**BCC DS**  
**RECEIVED**  
08-MAY-2026  
**APPLICATION REF**  
A007020190

DA Set - 21.02.2024.

DA Set - 15.02.2026.

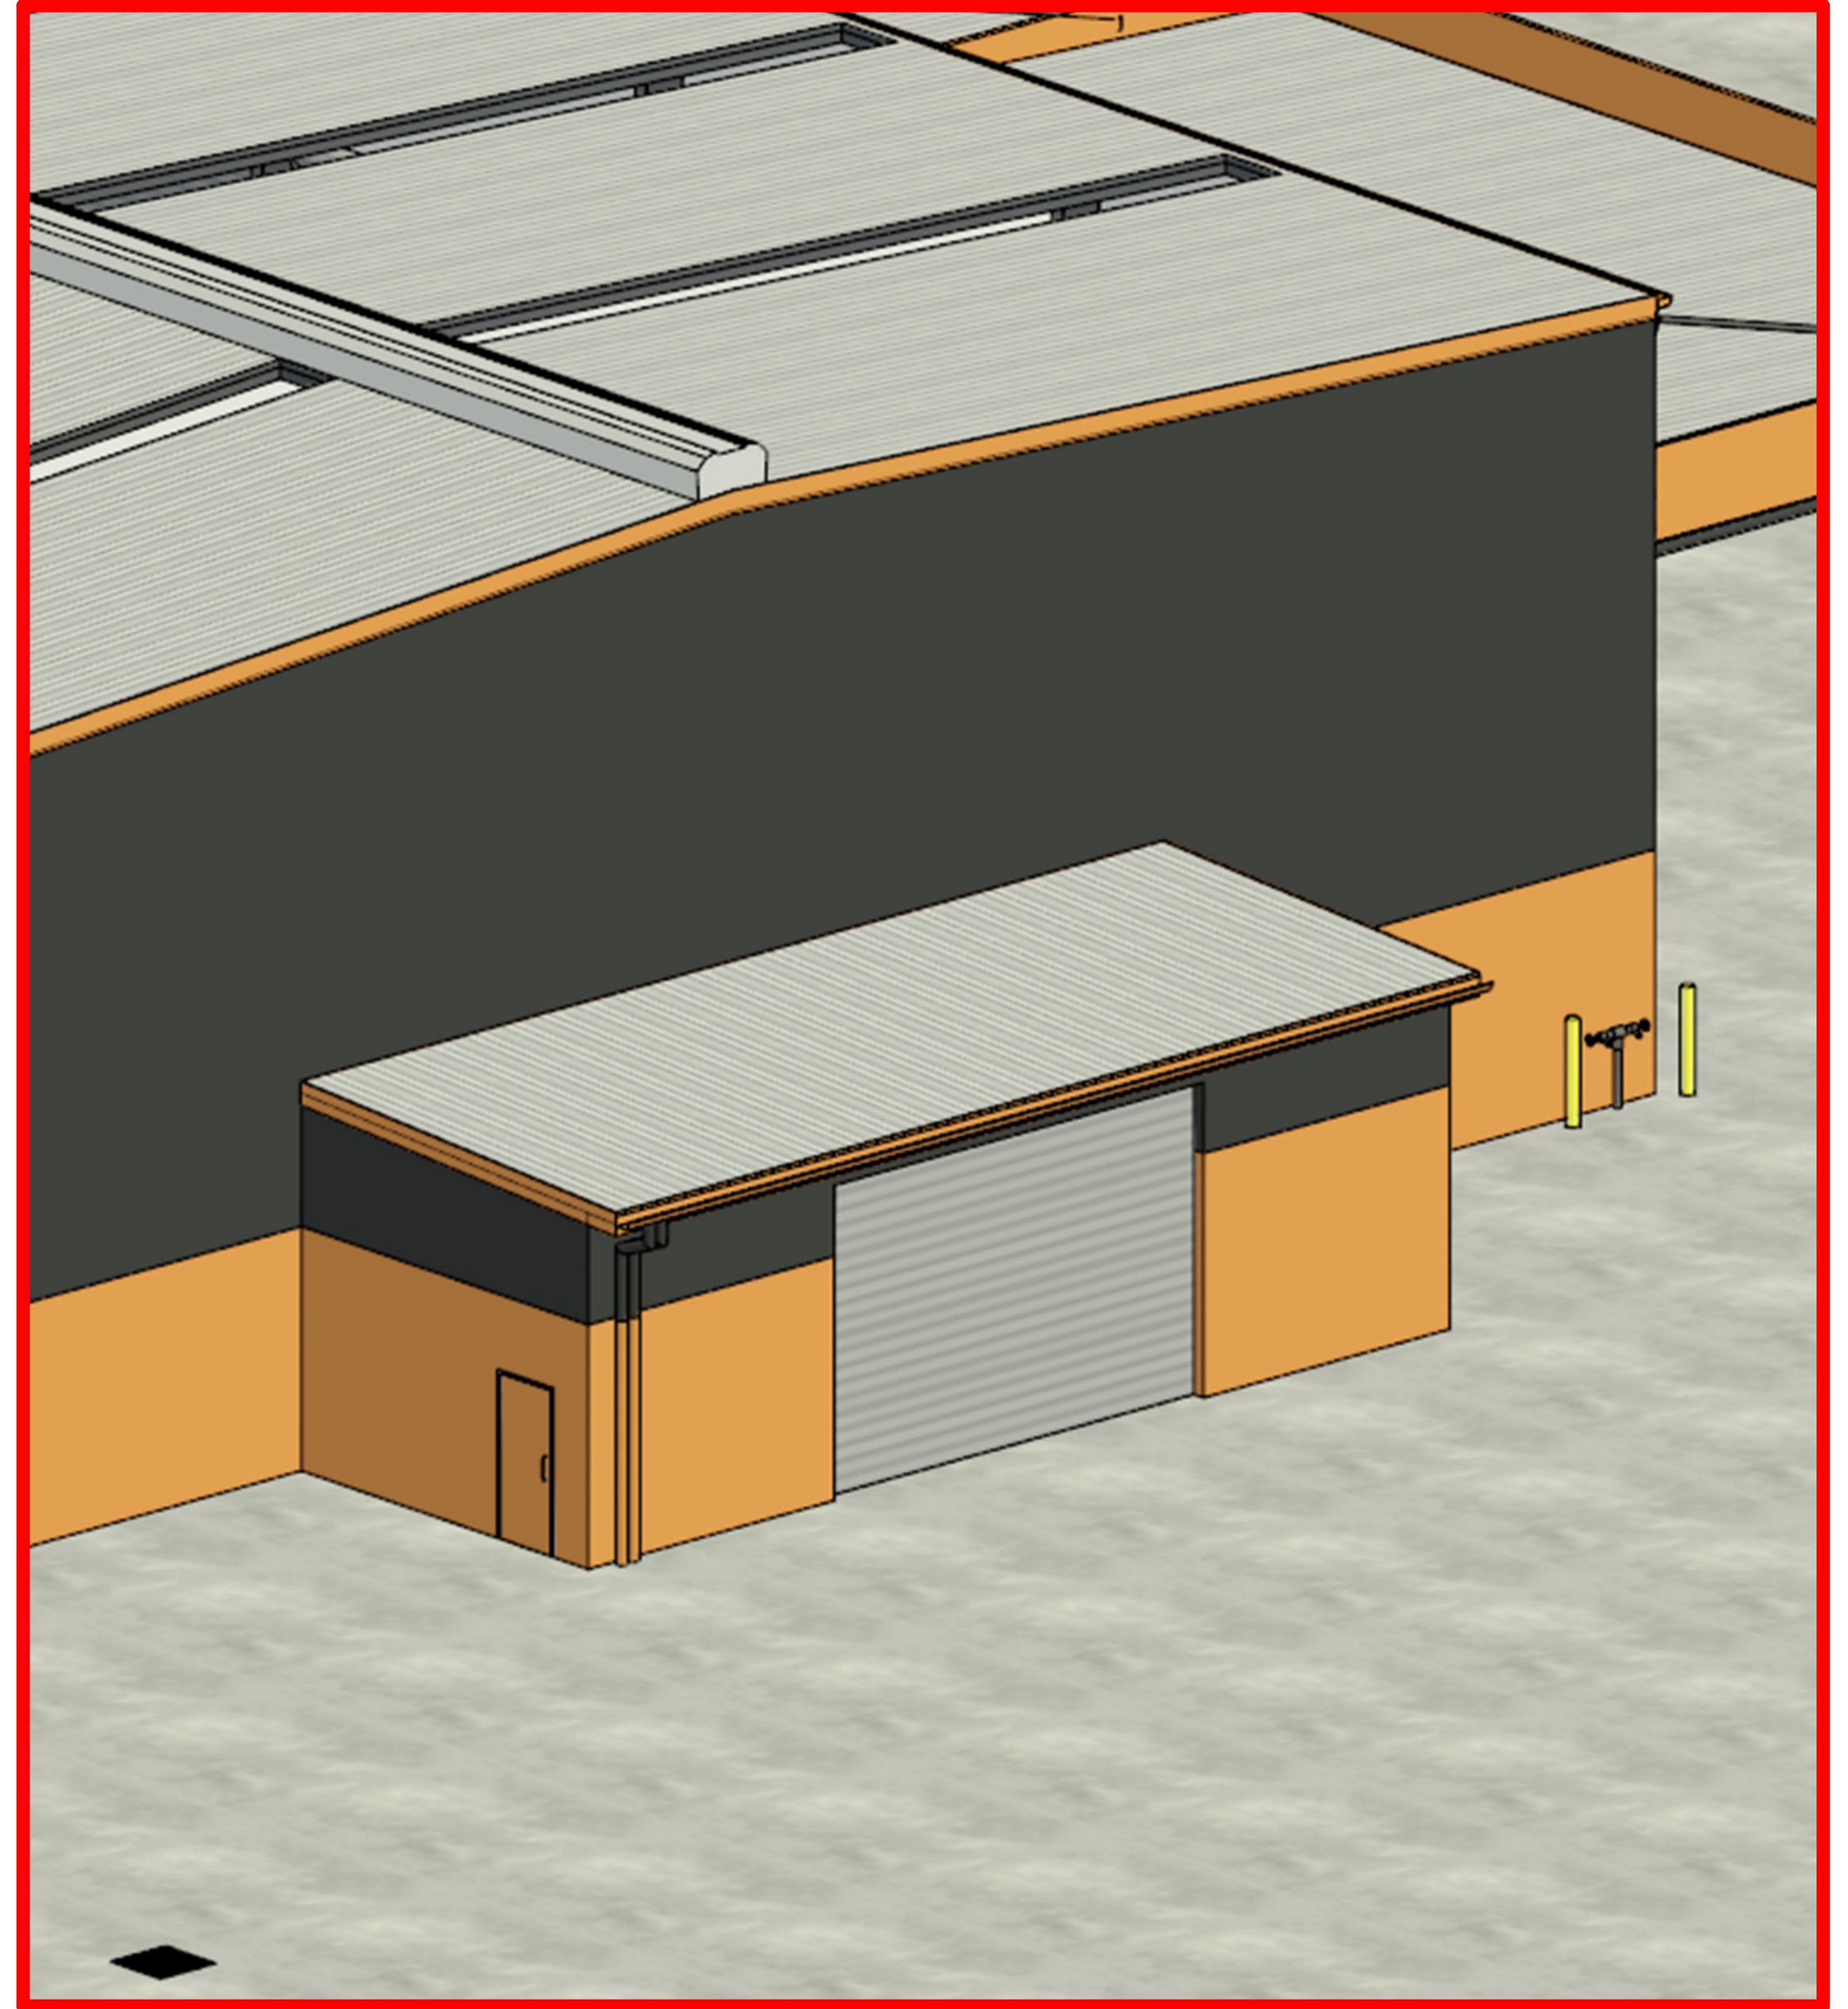
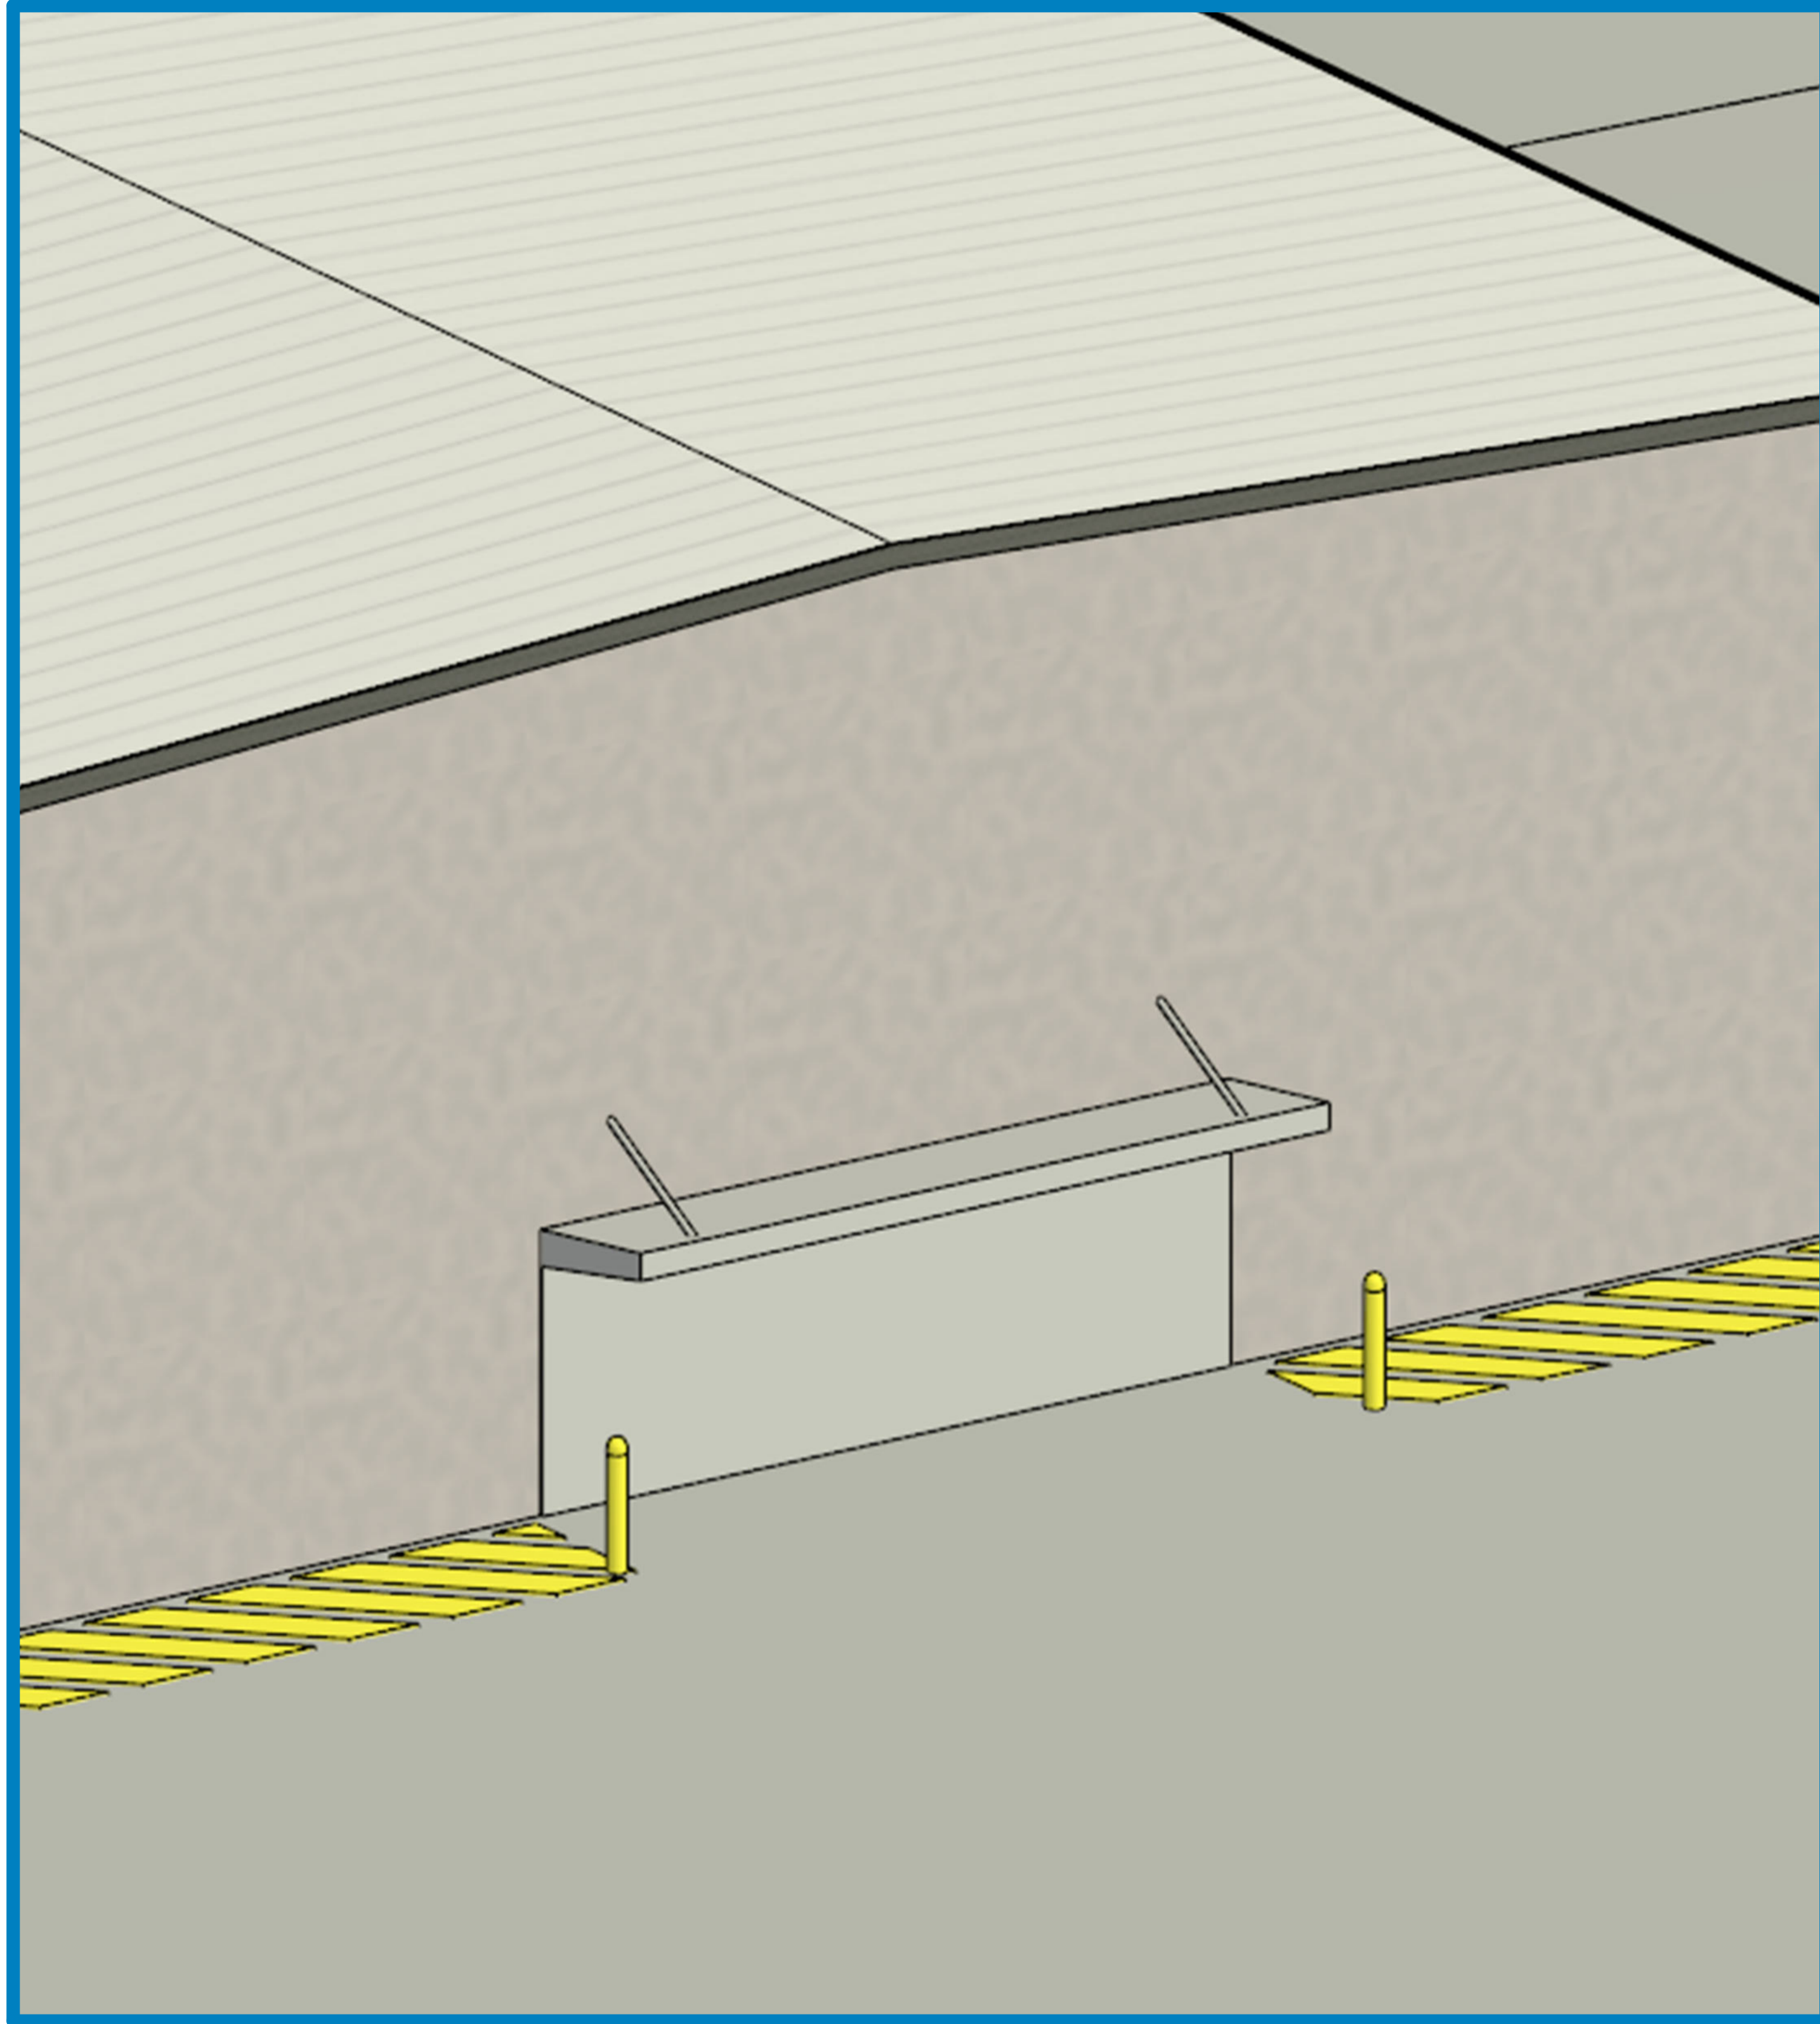
14. At the washdown bay, roller doors have been removed and replaced with open-sided access on both sides.

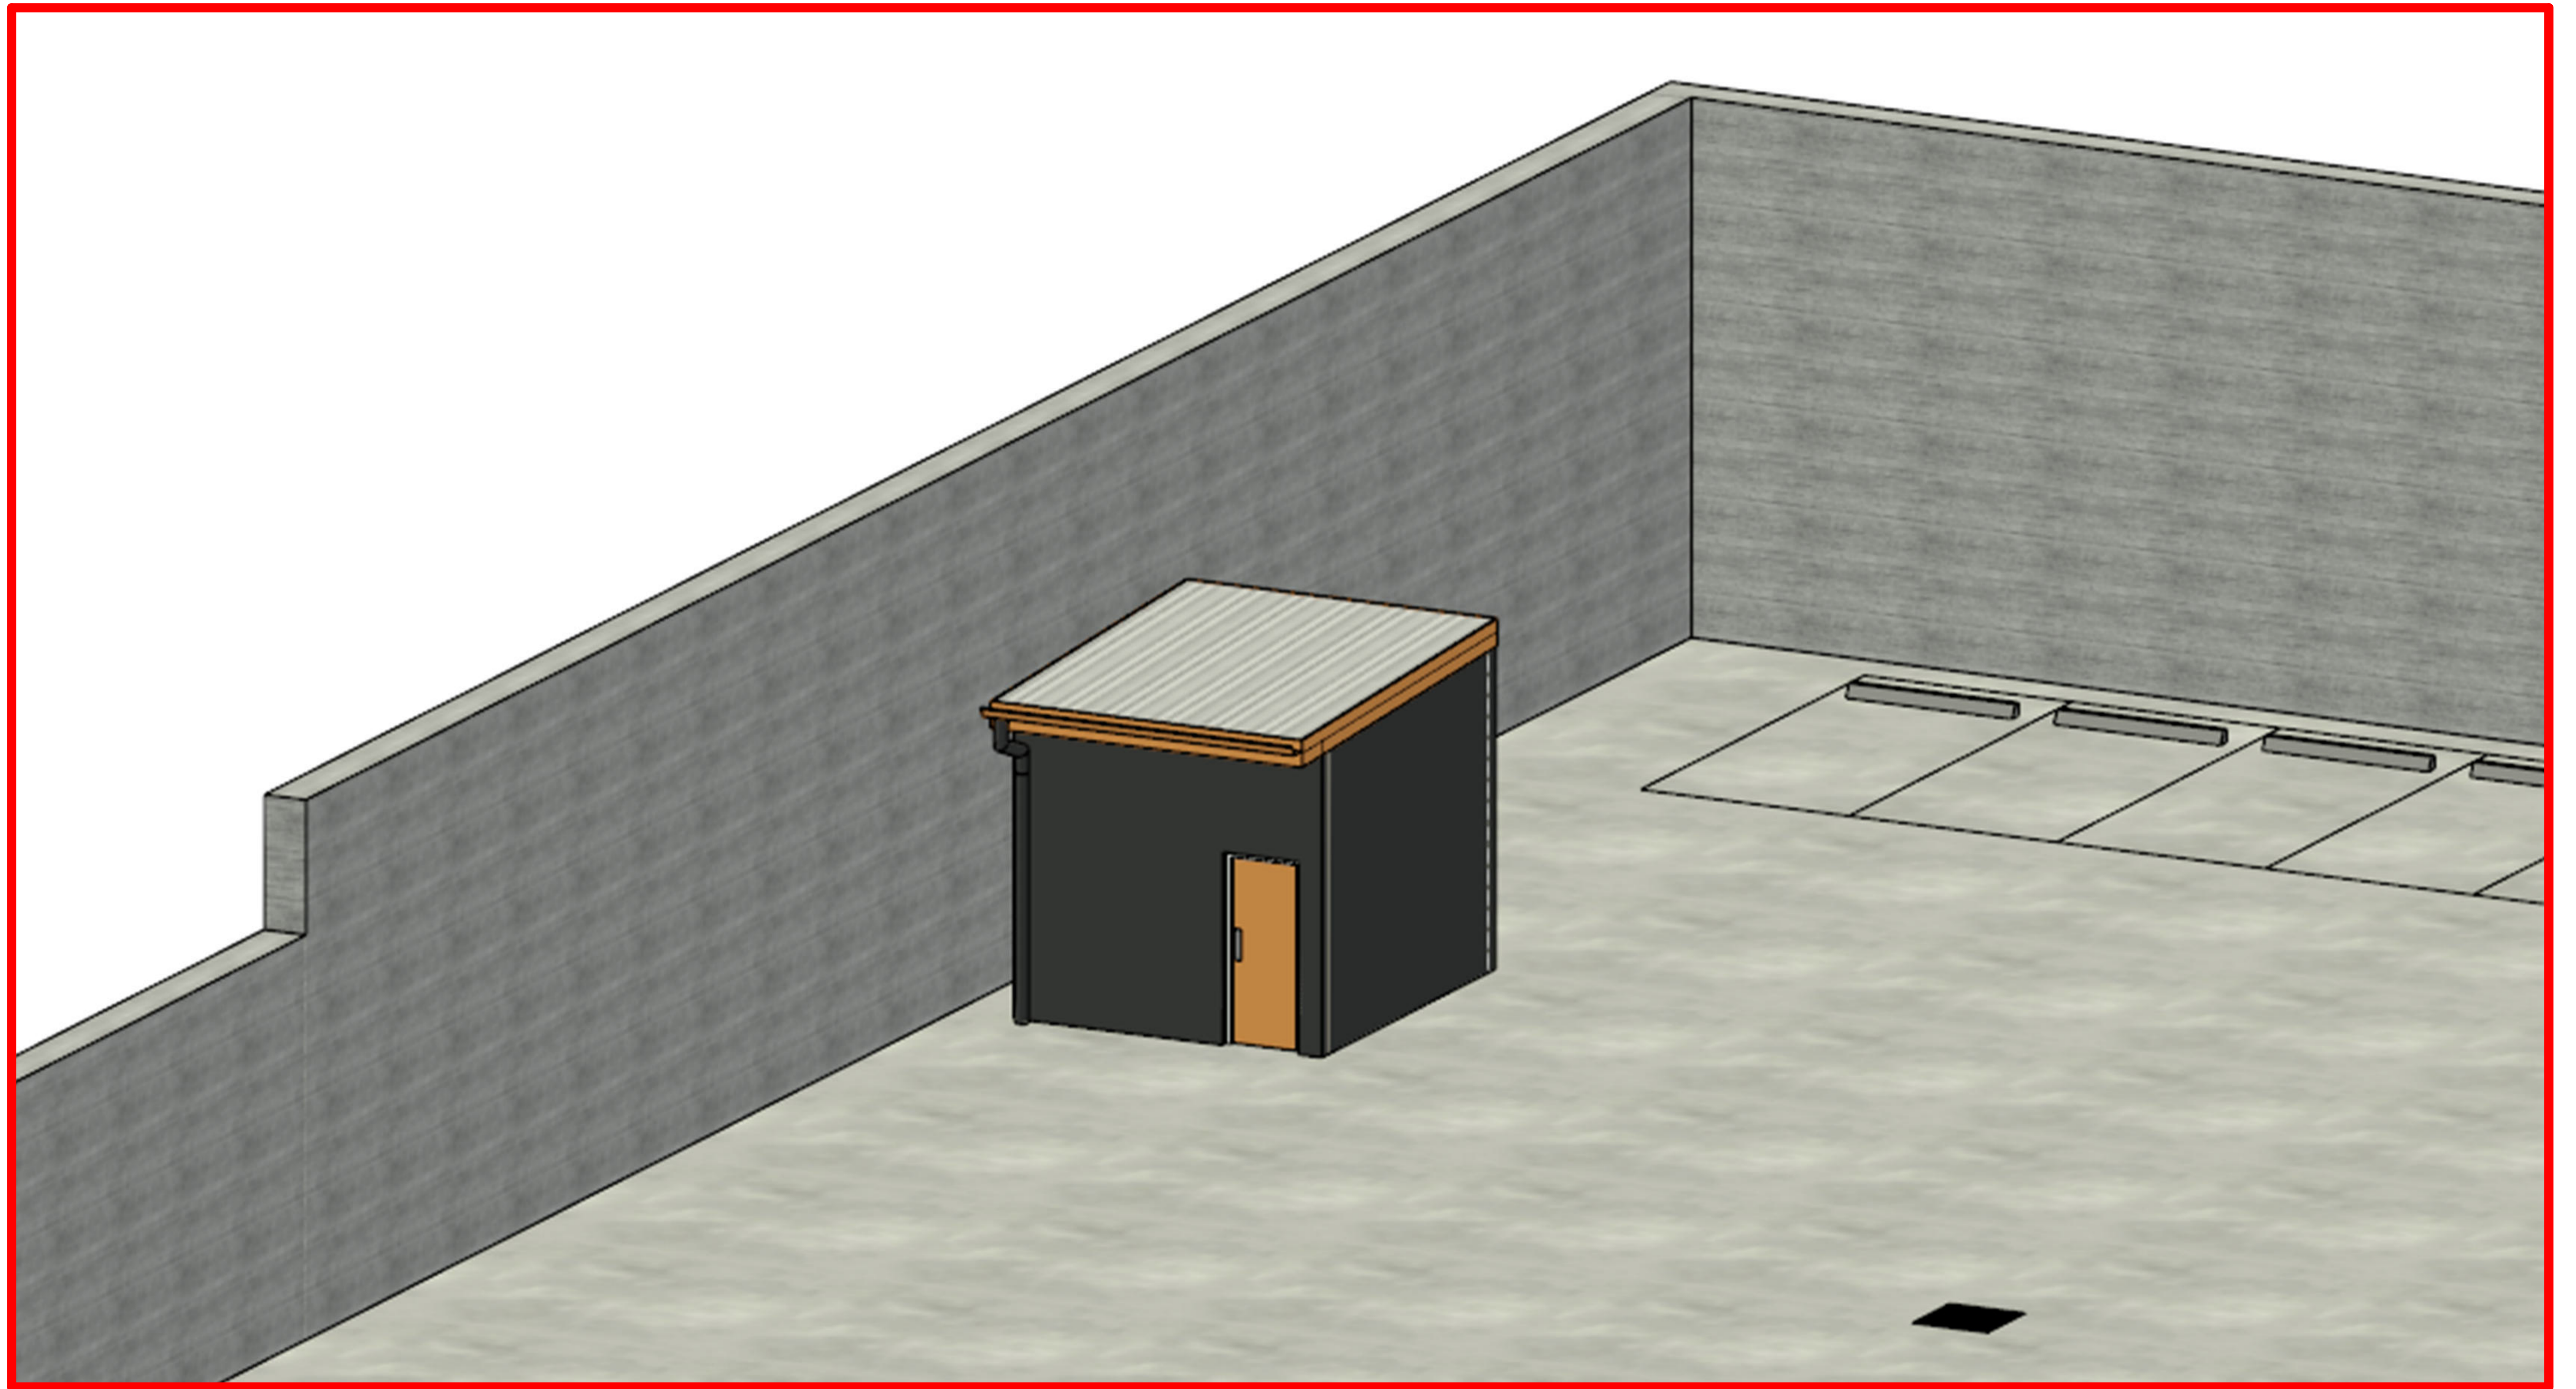
15. A smaller ancillary building has been added at the rear of the warehouse for storage and a compressor room.
